SUBJECT: Poplin Ridge- NCIRT Comments During 30-day Mitigation Plan Review

NCEEP Project Name: Poplin Ridge Stream Mitigation Site, Union County, NC

USACE AID#: SAW-2012-01079

NCEEP #: 95359

PROJ. DATE: JUNE 2013
 Q.C.: FM
 Q.C. DATE: 05-30-13
 DRAWING NUMBER:
15
 PROJ. NO.:
 20120118.00.RA

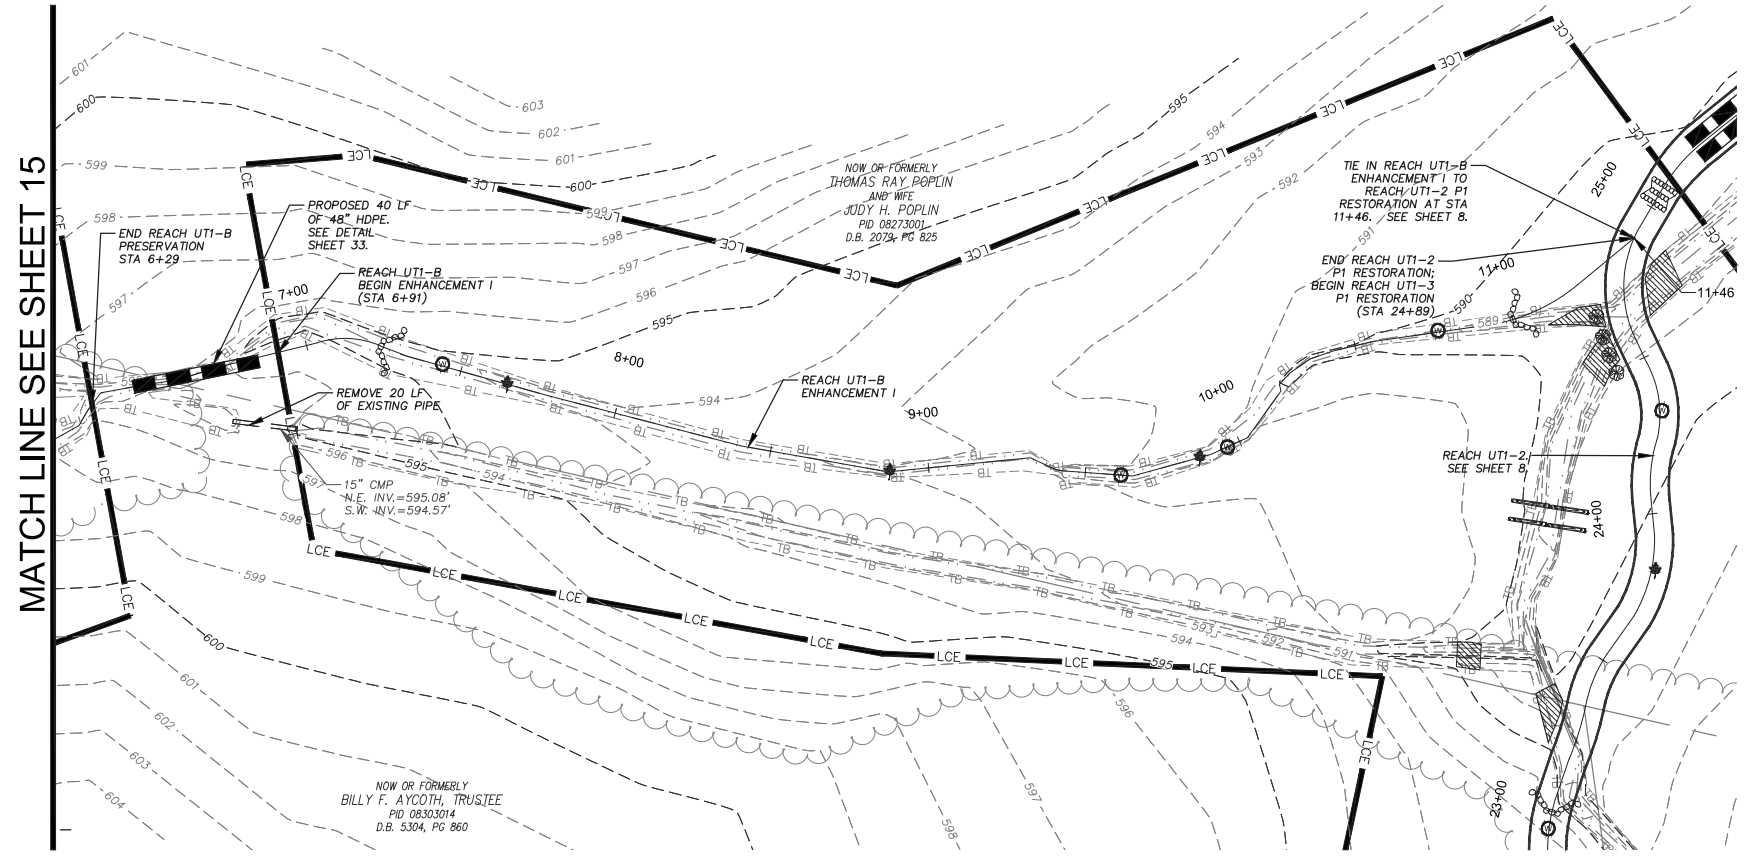
- Please discuss in further detail any required maintenance of the diffuse flow structures shown on Design Drawing #s 12, 15, 23, and 24.
- Section 9, pg. 67. Performance Standards: It is stated that the Performance Standards will be consistent with published federal rules, but additional District/EEP guidance must also be adhered to. Specifically the "Ecosystem Enhancement Program Monitoring Requirements and Performance Standards for Stream and Wetland Mitigation" Dated November 7, 2011. (Section IV C.) *All monitoring and performance standard

PROJ. DATE: JUNE 2013
Q.C.: FM
Q.C. DATE: 05-30-13
DRAWING NUMBER:
20
PROJ. NO.: 20120118.00.RA

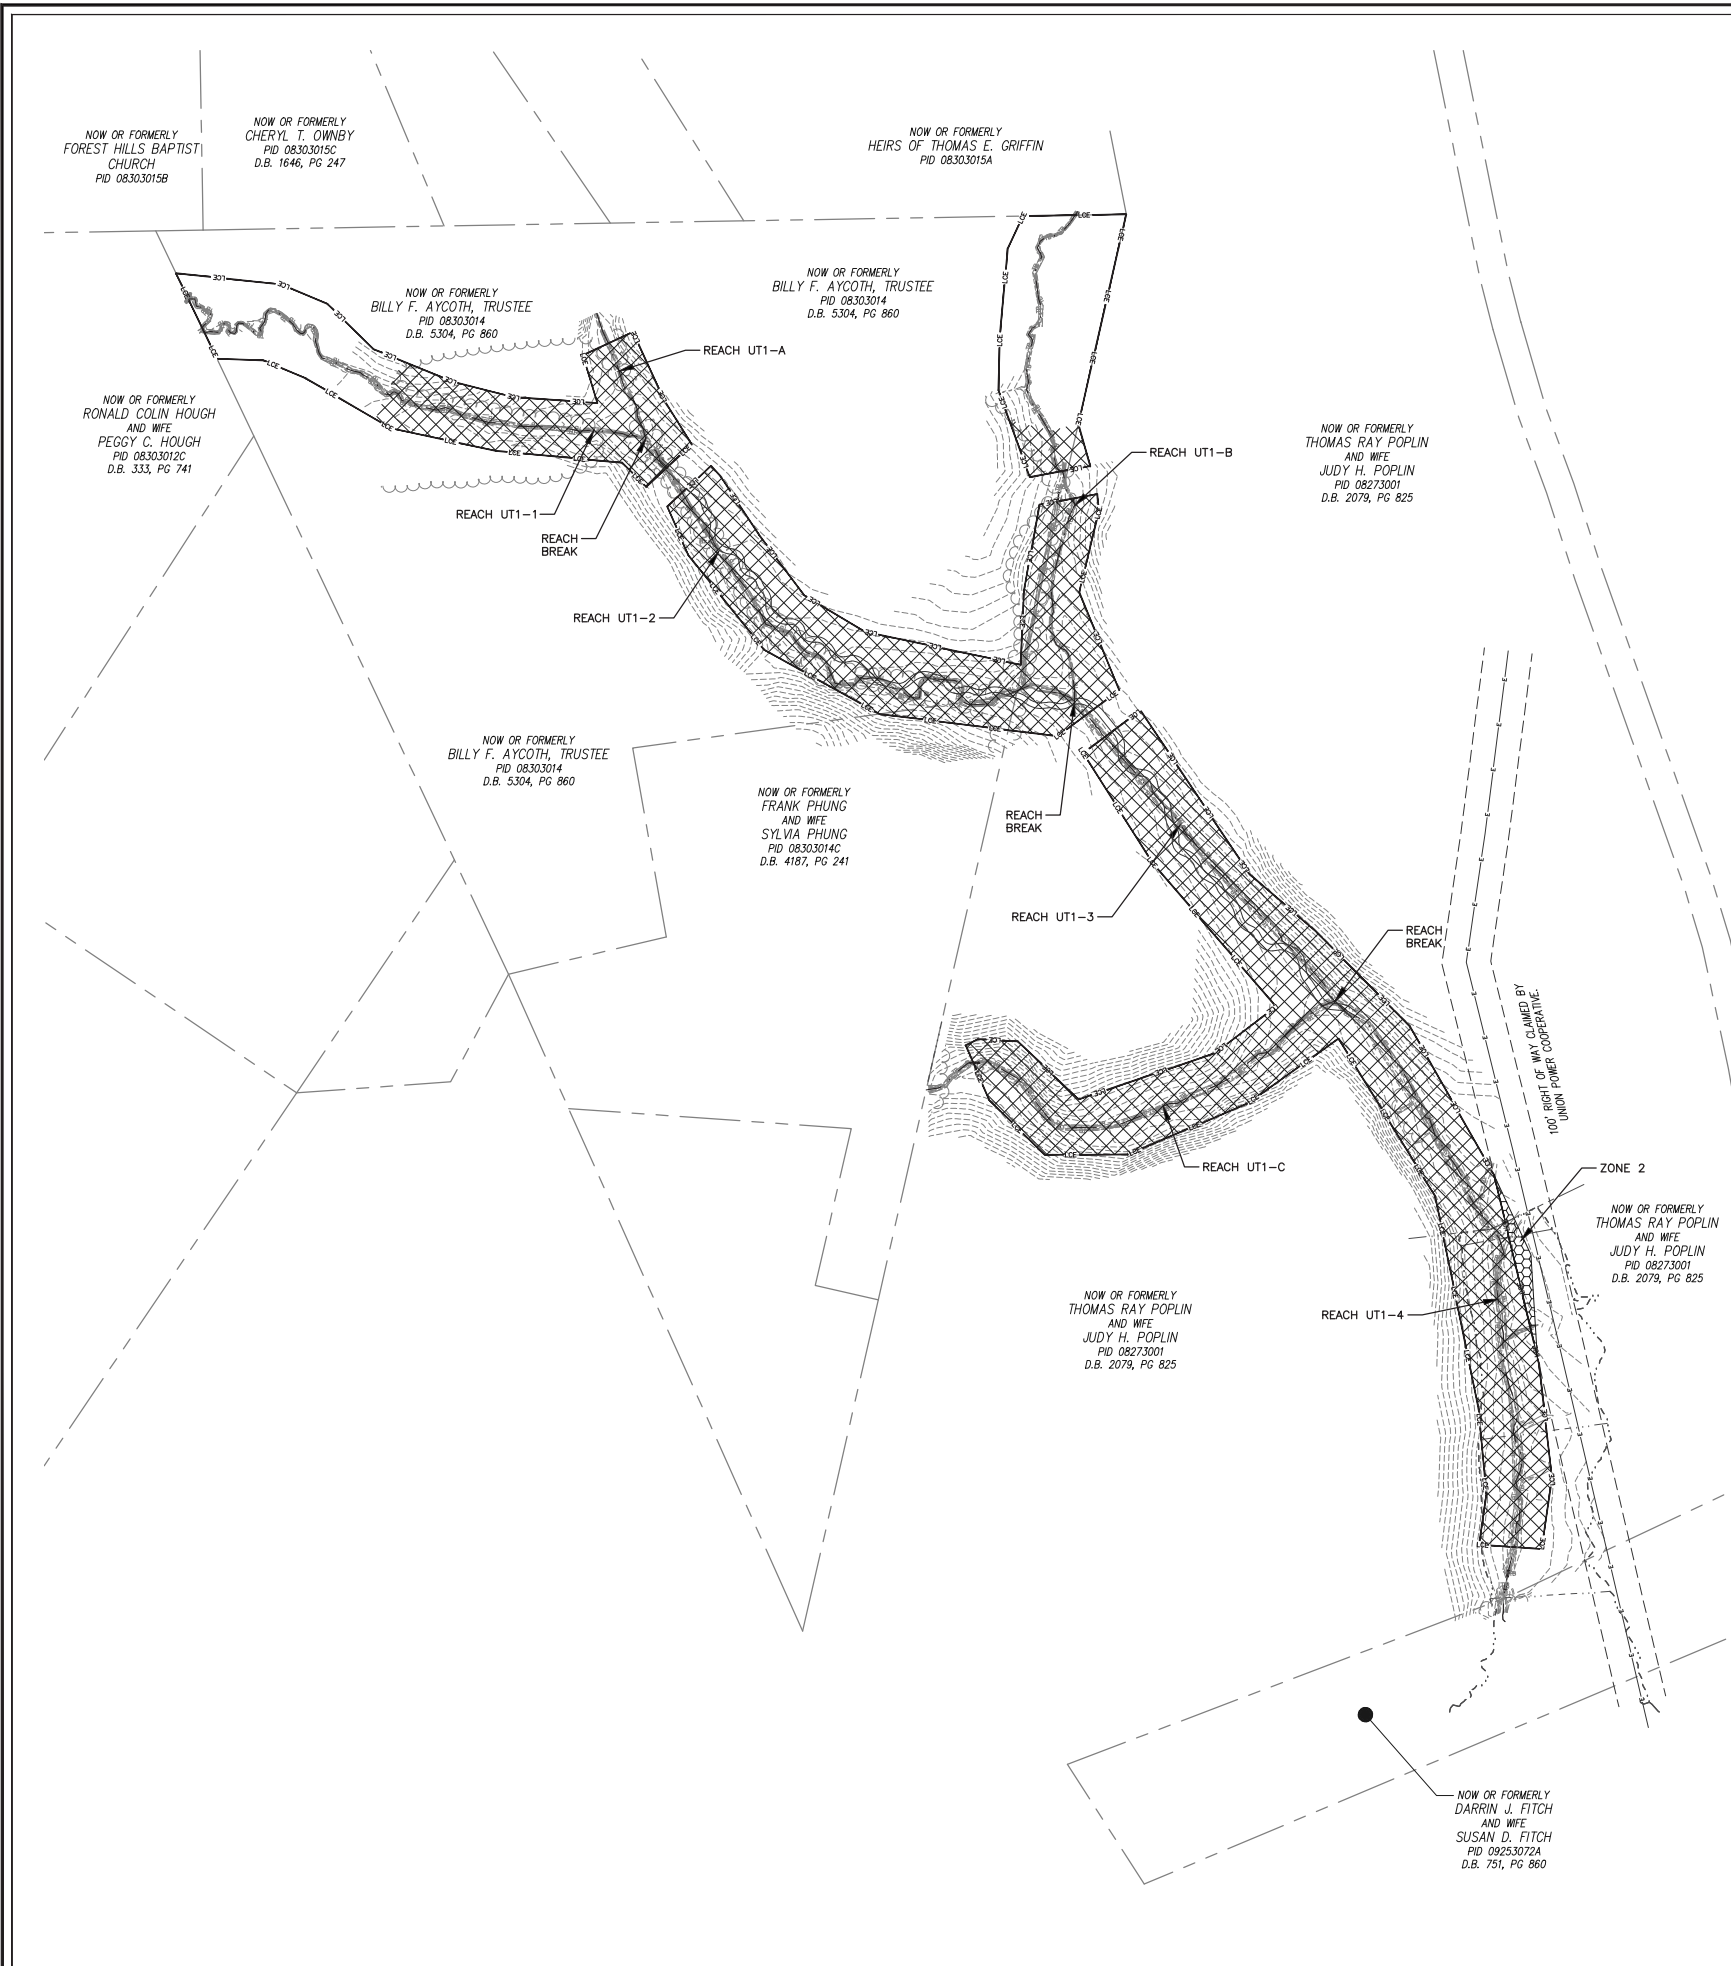
- Please discuss in further detail any required maintenance of the diffuse flow structures shown on Design Drawing #s 12, 15, 23, and 24.
